US EMBASSY ISLAMABAD, PAKISTAN

Location CMR

Title PROPOSED STAIR DRAWING

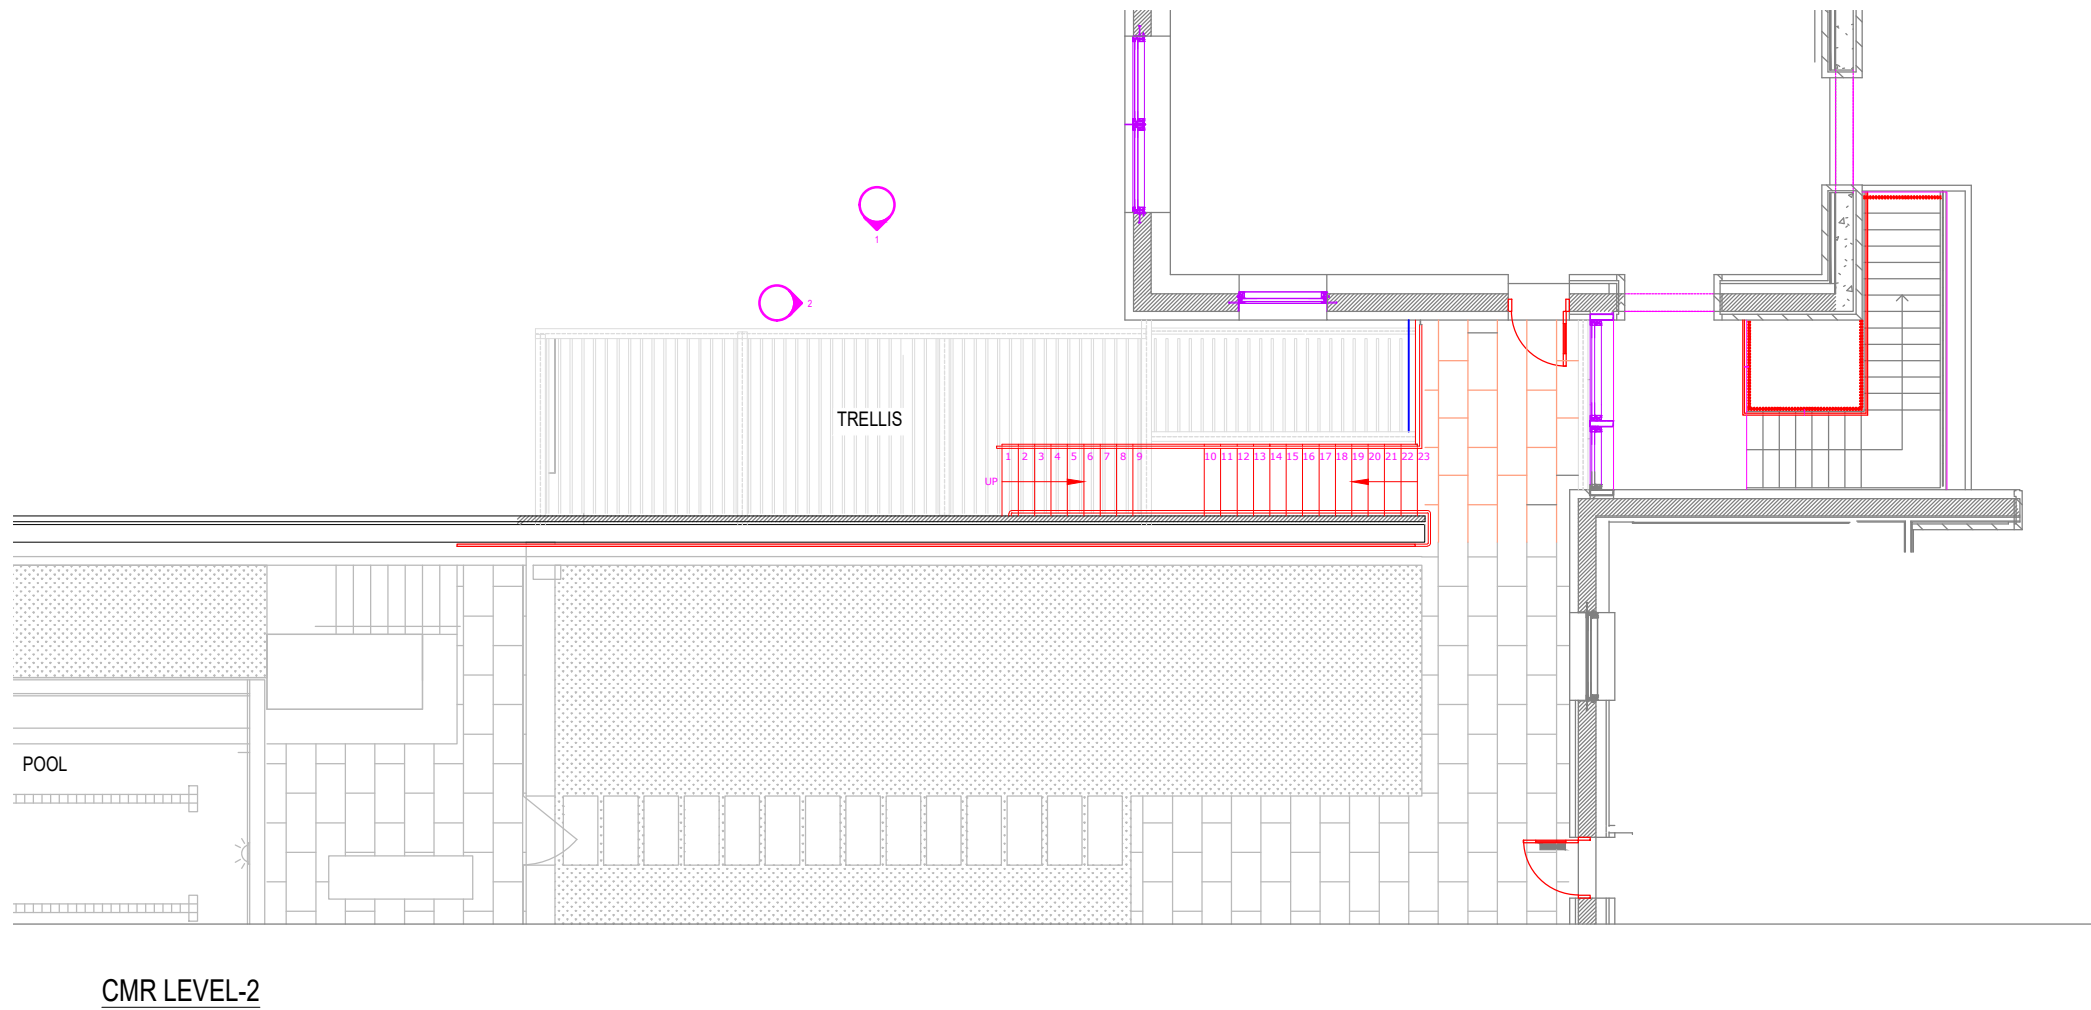
1 The Riser detail has been modified to meet code requirement of maximum opening allowance of 102 mm between risers.
